ISSUED 1998-11 REAFFIRMED 2007-06 REVISED 2022-03

BOLT, MACHINE - HEXAGON HEAD, DRILLED, 6 HOLES, FULL SHANK, UNS S66286, 130 KSI MIN, .5000-20 UNJF-3A

AS9588™
SHEET 1 OF 2

REV. C

FIGURE 1 - BOLT

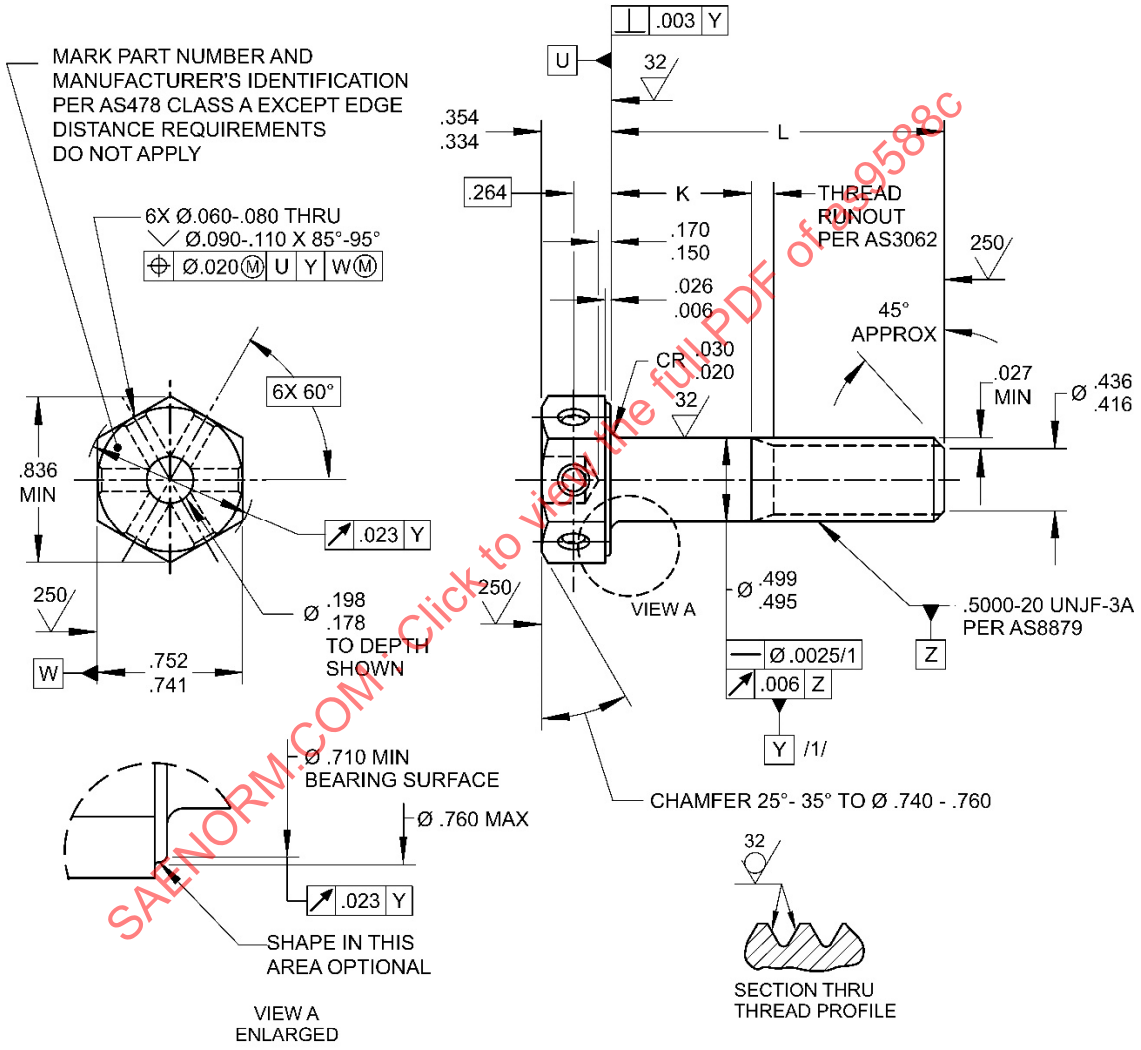
CORRECT TYPOGRAPHICAL ERROR IN HEAD HEIGHT DIMENSION, FIGURE 1 REDRAWN TO SHOW FULL SHANK PART AND UPDATE TO ASME Y14.5-2018, REVISE LEAD THREAD CHAMFER TO AS1132, REVISE HEAD TO SHANK FILLET RADIUS TO CR, ADD EDGE DISTANCE EXCEPTION FOR HEAD MARKING, GENERAL EDITORIAL UPDATES.
